Point Beach Nuclear Plant, Units 1 and 2
Dockets 50-266 and 50-301
License Nos. DPR-24 and DPR-27

Response to Request for Additional Information
Regarding the Point Beach Nuclear Plant License Renewal Application
(TAC Nos. MC2099 and MC2100) and
Request for Withholding of Proprietary Information from Public Disclosure

**RESPONSE TO POINT BEACH NUCLEAR PLANT, UNITS 1 AND 2
REGARDING LICENSE RENEWAL APPLICATION (LRA)
REQUESTS FOR ADDITIONAL INFORMATION (RAIs)**

Charging Nozzle

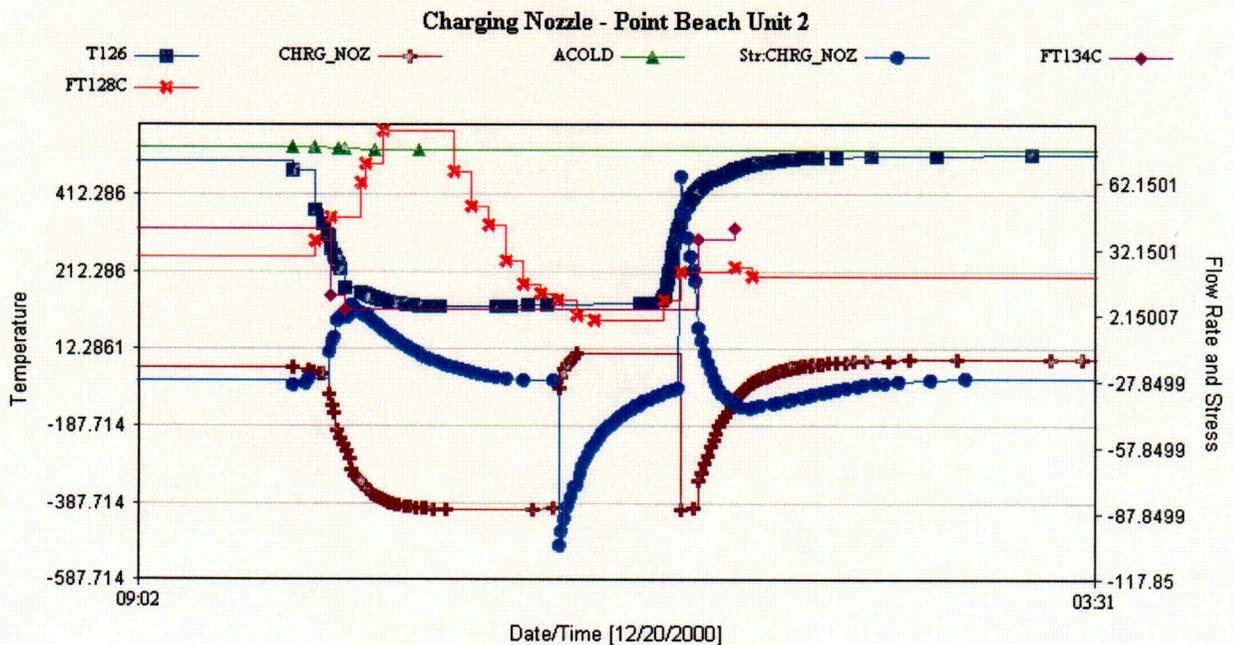
For the USAS B31.1 locations, provide a description of the PBNP-specific simplified ASME Section III fatigue analyses that were used to calculate environmentally based cumulative usage factors.

This location was analyzed using actual plant data and the projected number of cycles in the charging nozzle model included in a FatiguePro application for PBNP and the tensile strain-integrated environmental correction factor (F_{en}) factor.

The PBNP design basis includes several design transients that affect the charging nozzles. The most severe of these events is the loss of charging and loss of letdown with delayed return to service. Examination of actual PBNP Units 1 and 2 plant data since 1994 revealed one actual event that accurately represents this design transient. This event was used to represent a bounding loss of charging/loss of letdown event.

Normal fatigue usage for this event was computed. An F_{en} was then determined to account for environmental effects. The resulting total usage was applied over the expected number of occurrences for this event (17 loss of charging and loss of letdown events projected for the 60-year operating life of each units). The incremental fatigue usage attributed to the loss of charging/loss of letdown event was determined to be 0.00695. The bounding transient is depicted in the following figure.
